15557-TUL-XX-XX-RP-C-91002 Issue 01

Land East of Longwater Road, Finchampstead, Longwater Road, Wokingham, RG40 3TS.

Discharge of Condition Consultation (Application Number 260289)

Planning Response for Conditions 7, 9 & 11.

GUI003-TUL-XX-00-DR-C-95-306

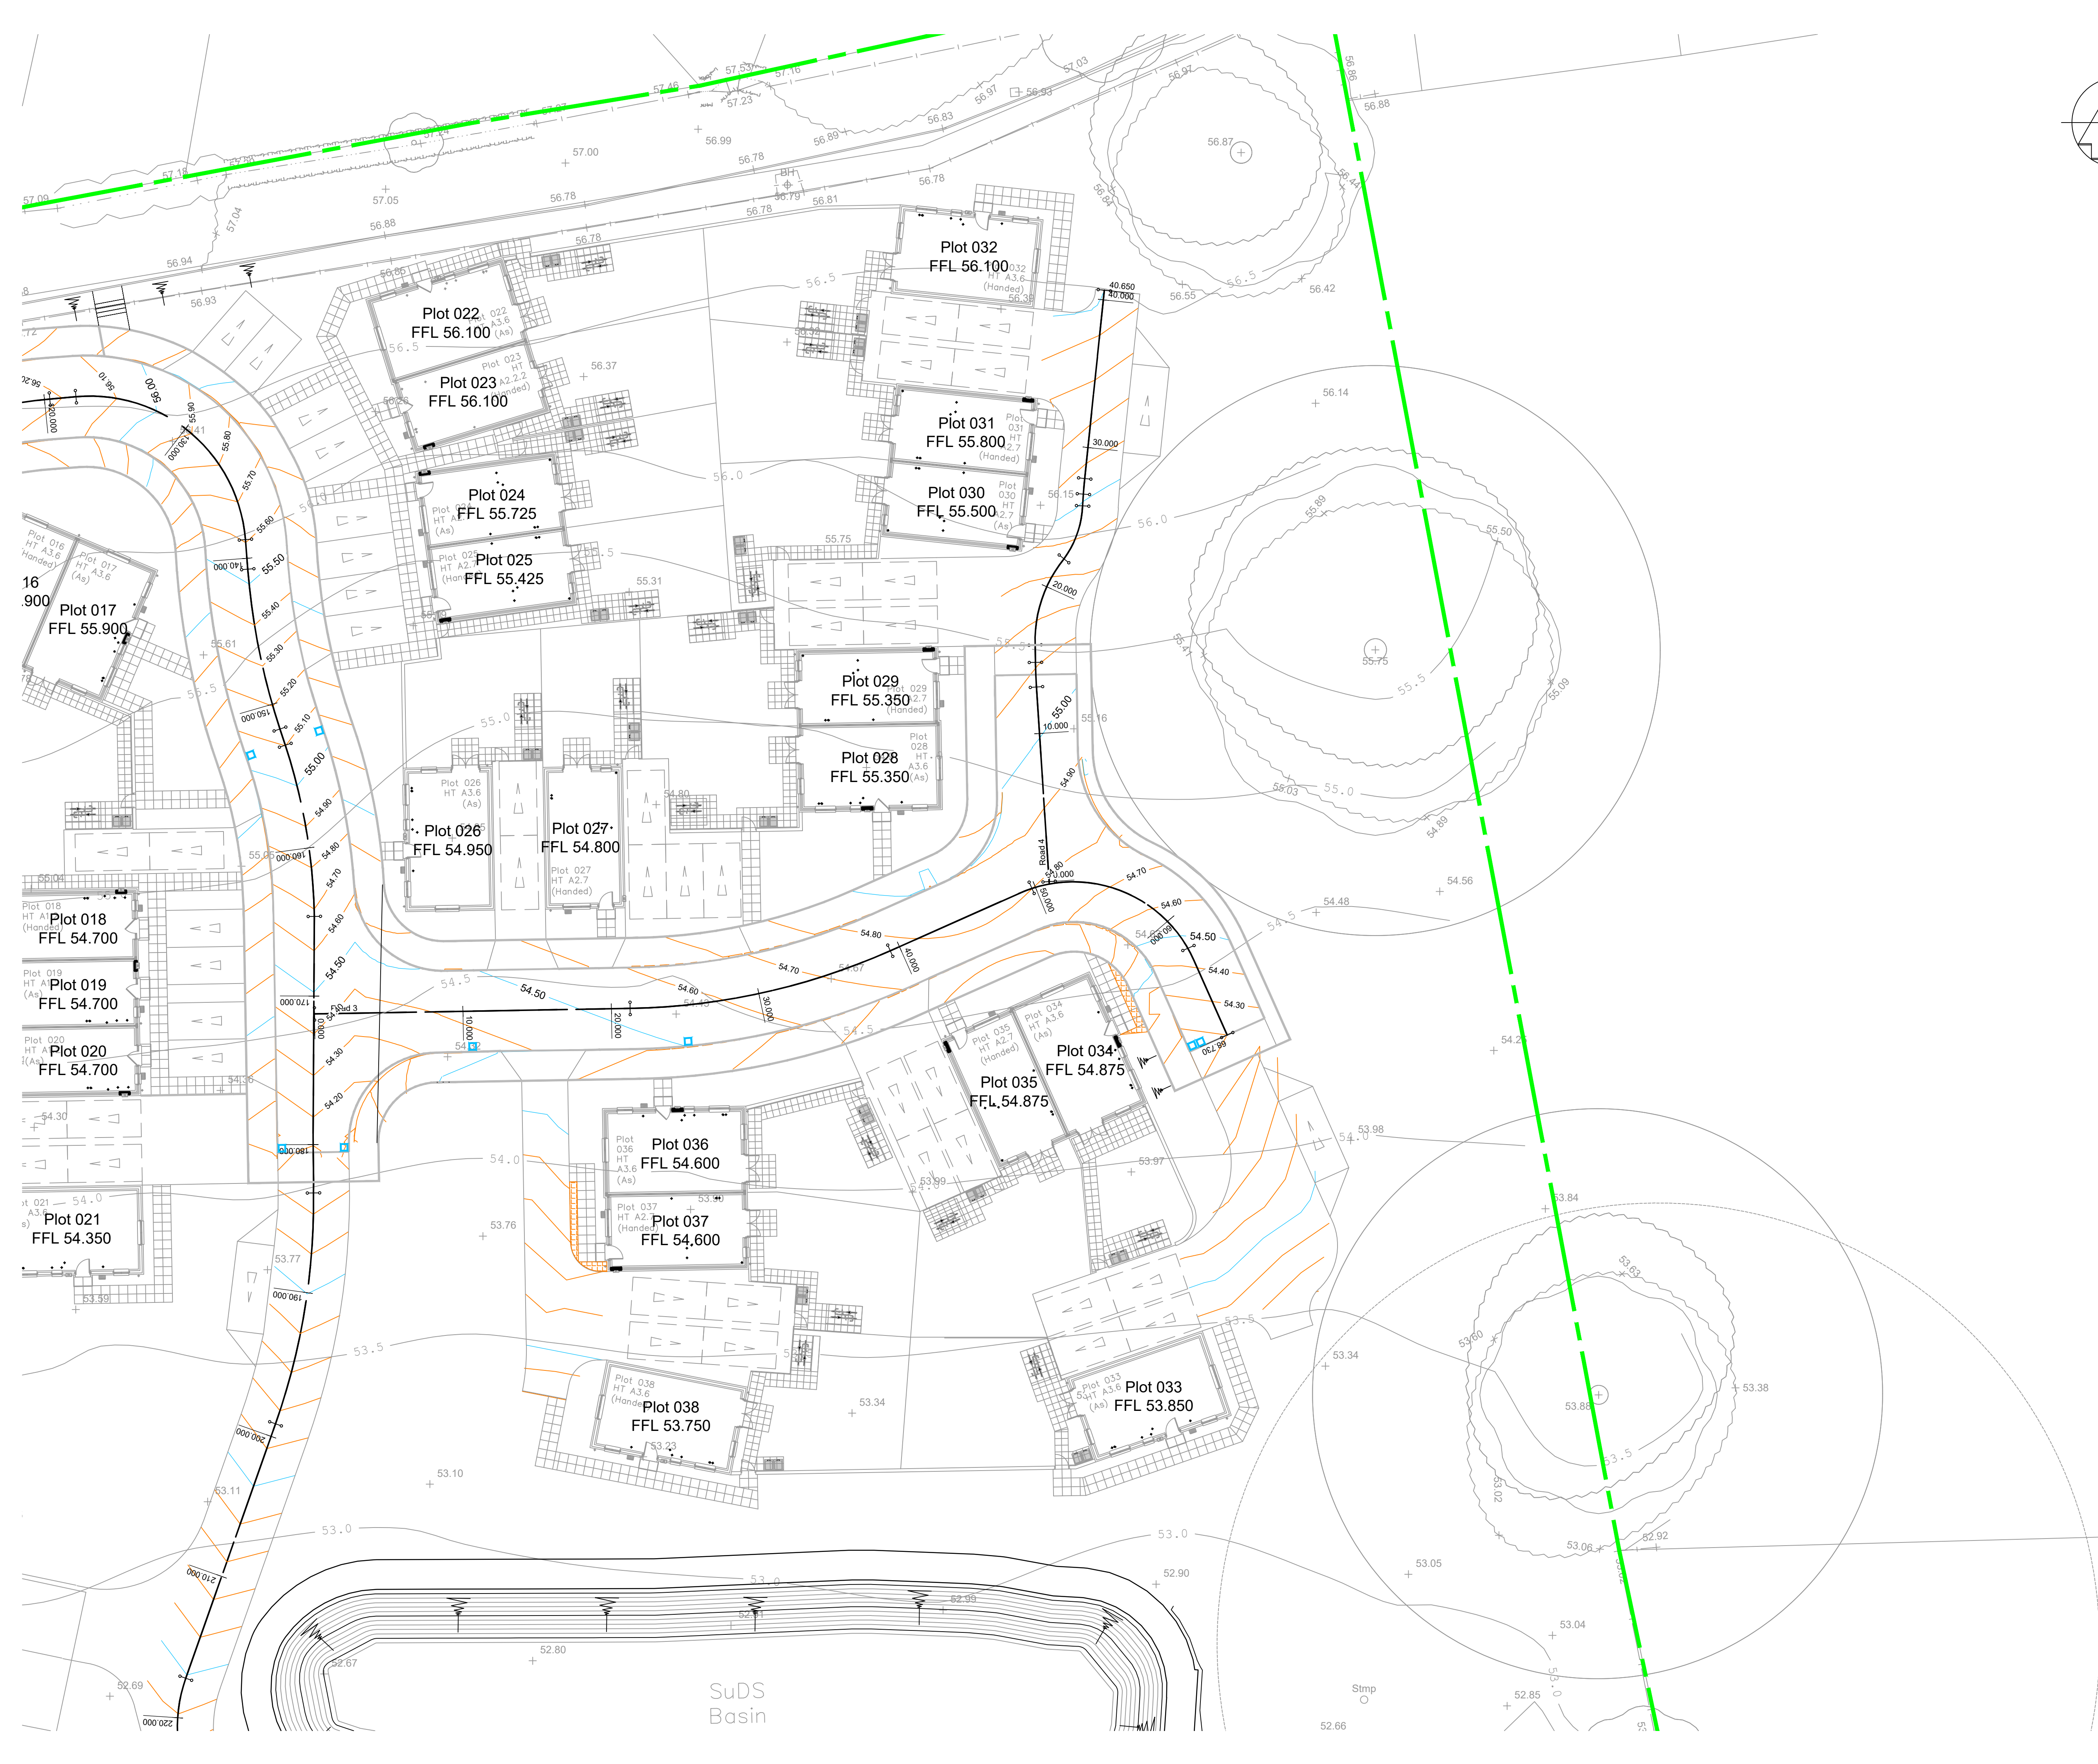
- *No markings are required on the internal site access roads. However, road markings are only required on the junction with the main road.*
- *Access to the PRow should be shown from the site access road. It is not clear how residents access the PRow from the site's internal access road.*

- *Tactile paving should be shown across the entire site at dropped kerb crossing points.*
- *Gullies on the contour plan should be shown.*
- *Clarification is required as to whether the drainage pond will be adopted or private.*

- Pedestrian links to PRow added to site layout.

Refer to drawings GUI003-TUL-XX-00-DR-C-95-301_C03, GUI003-TUL-XX-00-DR-C-95-302_C03, GUI003-TUL-XX-00-DR-C-95-305_C03, GUI003-TUL-XX-00-DR-C-95-306_C03, GUI003-TUL-XX-00-DR-C-95-307_C02.

- Tactile paving added to the internal site.

Refer to drawings GUI003-TUL-XX-00-DR-C-95-301_C03, GUI003-TUL-XX-00-DR-C-95-302_C03, GUI003-TUL-XX-00-DR-C-95-305_C03, GUI003-TUL-XX-00-DR-C-95-306_C03, GUI003-TUL-XX-00-DR-C-95-307_C02.

- Gullies added.

Refer to drawings GUI003-TUL-XX-00-DR-C-95-305_C03, GUI003-TUL-XX-00-DR-C-95-306_C03.
